### Staff Report – Design Permit Application

**To:** Leavenworth Design Review Board  
**From:** City of Leavenworth Development Services Department  
**Date of Report:** December 15, 2021  
**Subject:** Architectural Design Permit – “Wanderlust Hotel”  
**Permit:** DRB 2021-034  
**Hearing Date:** December 22, 2021

# EXHIBIT A

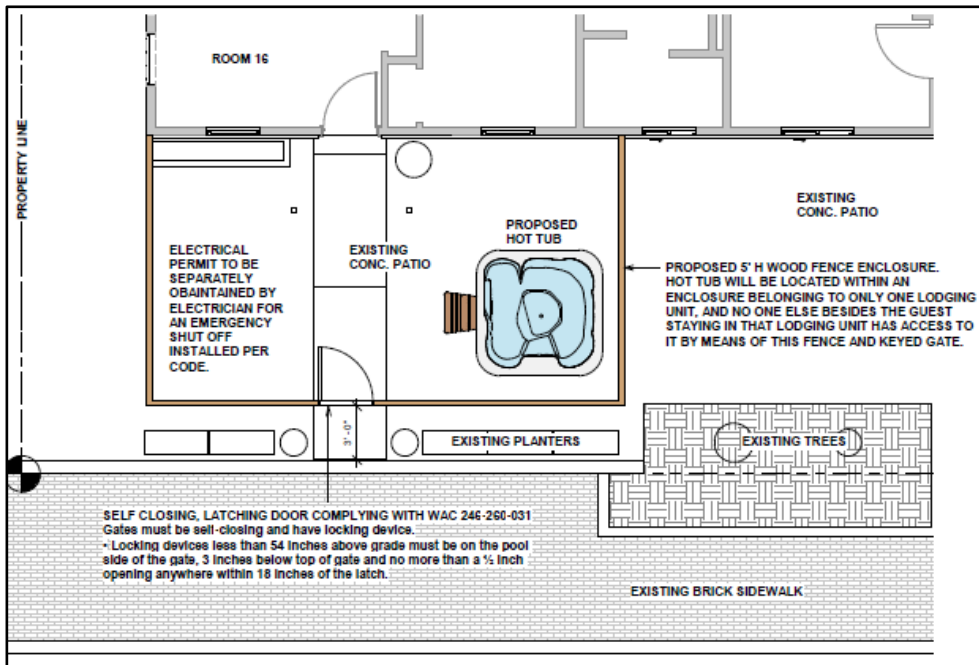
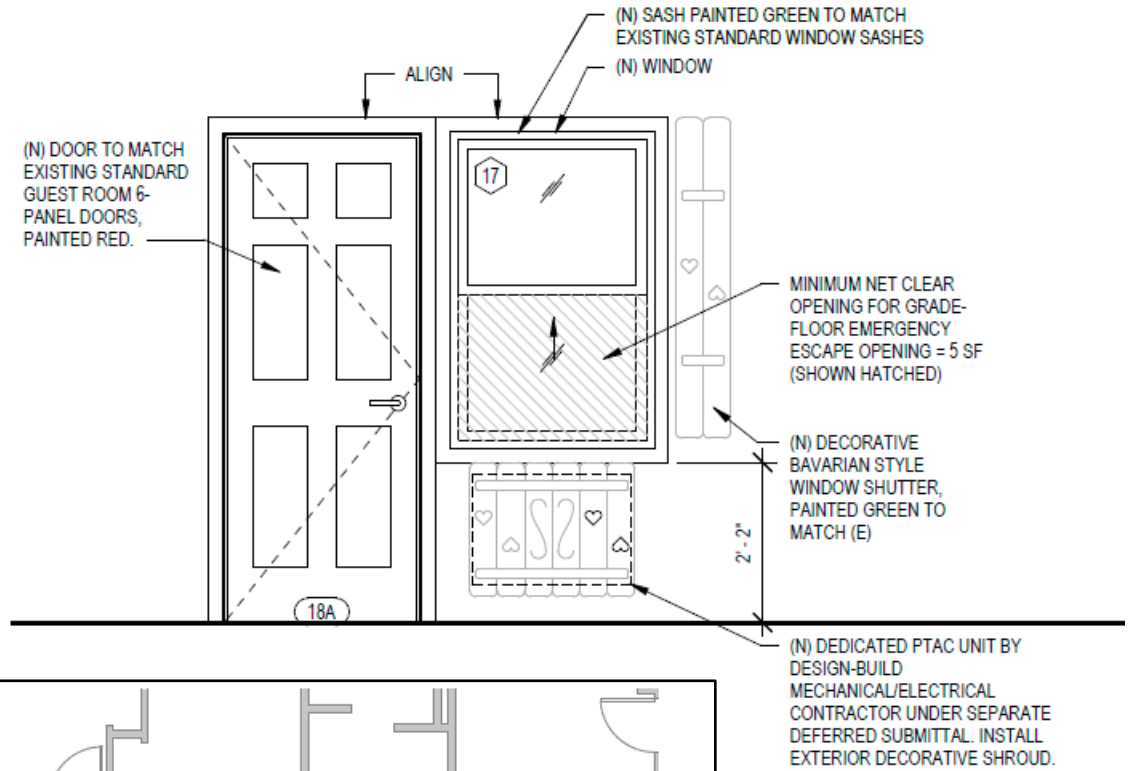
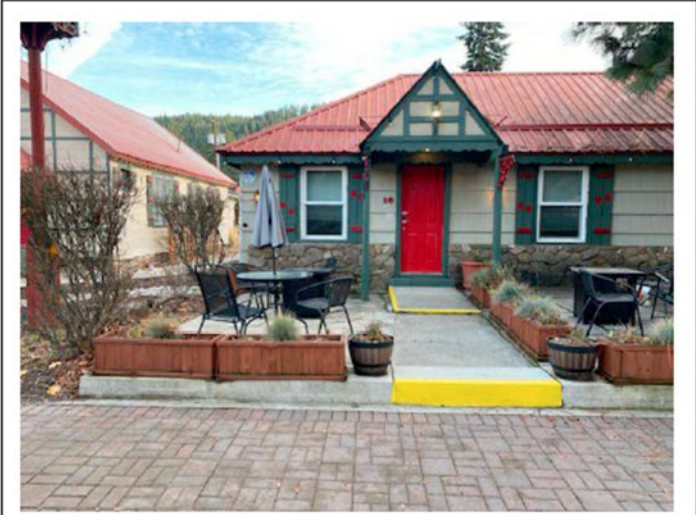
- A) **Hot Tub Enclosure Fencing** – The Applicant proposes to install a new five-foot tall wood fence with Penofin Red Label Transparent Hickory stain. The fence will be setback three feet from the property line along the front of Unit 16.
  - a. The Applicant failed to provide details on the lumber dimensions and hardware.
  - b. The fence material is consistent with LMC 14.08.040(B)(7).
  - c. Fencing must comply with LMC 15.06; A separate fence permit is required.
    - 1. The Applicant has submitted a fence permit, BLD2021-115, which is pending approval of this architectural design application.

- B) **Door & Window Installation** – The Applicant proposes installation of a new door and window to be added to the existing building, for a new rental unit. The door will be designed to mimic the existing doors on the building; a six-panel, paint-grade wood door, painted red. The window will also be designed to mimic the existing windows, with a 2’-9 ½” x 4’-4” window (undisclosed material), with a painted green sash and new single shutter (same design and color as those existing on building).
  - a. The Applicant failed to provide window material detail.
  - b. Pursuant to LMC 14.08.040(F), when shutters are used, they shall be proportional to the window and appear operable.

- i. The proposed shutter is inconsistent with the code. While it matches the others shutters on site, staff cannot recommend approval of a noncompliant element for *new* construction.
- c. Window mounting details have not been provided. Flush-mounted windows are unacceptable.

- C) PTAC Unit – The Applicant is proposing to install a new PTAC unit under the new window. The unit will be screened by an exterior decorative shroud, to mimic the existing screening onsite. It will be colored green with red detail.
  - a. The screening appears to include Old World Bavarian elements.
  - b. Green and red are listed as approved Old World Bavarian Colors.
  - c. The PTAC unit may require standard clearances, in accordance with the manufacturer’s instructions. Changes to the screening may be necessary.

- 2.1. The Applicant shall provide fence hardware details to the City for review and Administrative Approval, prior to installation.**
- 2.2. The proposed shutter shall be modified to be proportional to the window and appear operable; or, the shutter shall be removed and replaced with a different window treatment option, per LMC 14.08.040(F).**

- 2.3. The Applicant shall provide City Staff with window mounting and material details. The new window shall be recessed (preferably 3 inches), and the window trim shall be wood or wood in appearance.**

- 2.4. The PTAC unit screening may require minor modification, to ensure clearances around the unit are met (per the manufacturer’s installation guide). Any changes to the approved screening shall be reviewed and approved by City Staff prior to installation.**
